RECALL BULLETIN:
91209FRV

PRODUCT(S) AFFECTED:
Jamboree Sport, Tioga Ranger with serial numbers listed in this Bulletin

MODEL(S) AFFECTED:
25G

SUBJECT:
Reroute Propane Plumbing Away From Chassis Suspension

Figure 2

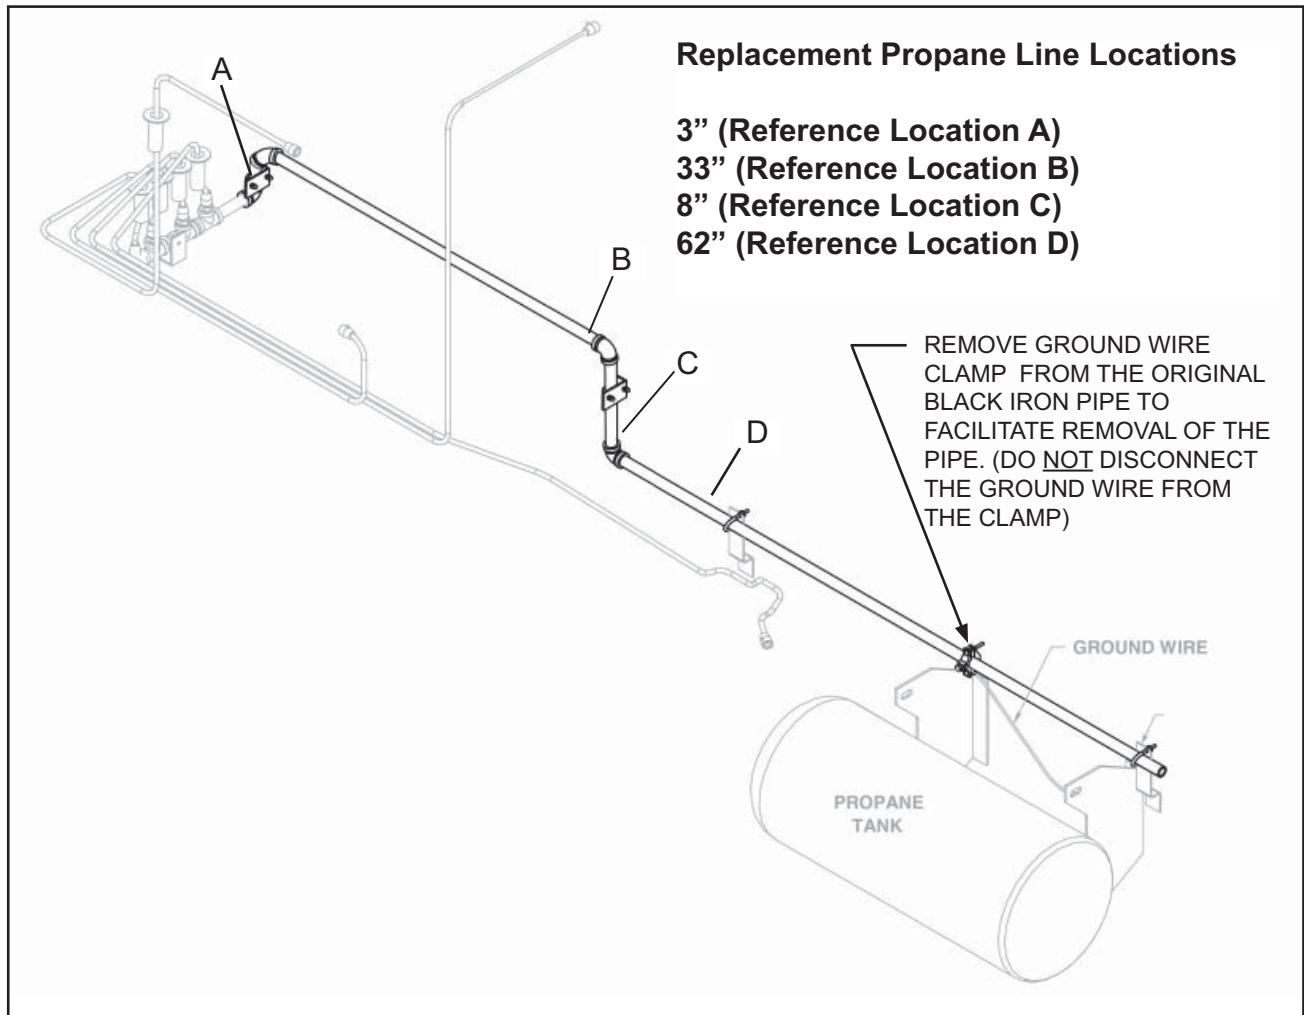
The black iron Propane plumbing, located under the motor home, may come into contact with chassis components and, under certain conditions, become pinched or crushed. This may result in a propane gas leak and the potential for an explosion and/or fire.

NOTE: The bold lines shown in Figure 2 (next page) illustrate the portions of propane plumbing that are to be removed and replaced in the following steps.

15. Remove and discard the two sections of black iron propane pipe and the two black iron elbows that were originally routed between the propane manifold and the propane tank flexible hose. Refer to Figure 2.

16. Blow compressed air through all new plumbing sections to remove debris before installation.
17. Connect a new 90° elbow to one end of each of the following three lengths of new pipe, and tighten:
 - 3" (Reference Location A)
 - 33" (Reference Location B)
 - 8" (Reference Location C)

21. Attach the new 33" length of pipe to the elbow on the end of the 3" pipe nipple. (This length will span the area across the wheel well.) Tighten the connection until the elbow at the other end faces down. See Figure 2, Reference Location B.

22. Attach the new 8" section of pipe to the elbow connection for the 33" pipe installed in the previous step. Tighten until the elbow at the other end faces the front of the motor home. See Figure 2, Reference Location C.

23. Attach the new 62" section of pipe to the elbow connection for the 8" section of pipe installed in the previous step. Tighten. See Figure 2, Reference Location D.

24. Relocate the support brackets for the propane pipe as required, then install new U-bolts to secure the Propane plumbing. Fasten each U-Bolt with two new flat washers and two new locking nuts. Add additional support brackets and U-bolts (with fastening hardware) as required. The black iron pipe must be secured within 6" of connections (elbows) at end of runs, and at intervals not to exceed 48" on center.

Figure 3
Sub-assemble the manifold, pipe nipple, and two 90° elbows as shown before reinstalling the manifold

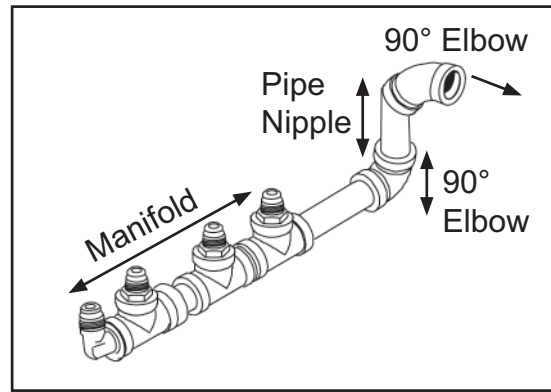
18. Remove the protective tape from the manifold and attach a new 90° elbow at its open end. Tighten until the elbow points in the same direction as the ports on the manifold. (This elbow is to point up after the manifold is reinstalled.) See Figure 3.

19. Connect the 3" pipe nipple to the new 90° elbow installed on the manifold in the previous step. Tighten the connection until the elbow at the opposite end forms a 90° angle, and is assembled as shown in Figure 3.
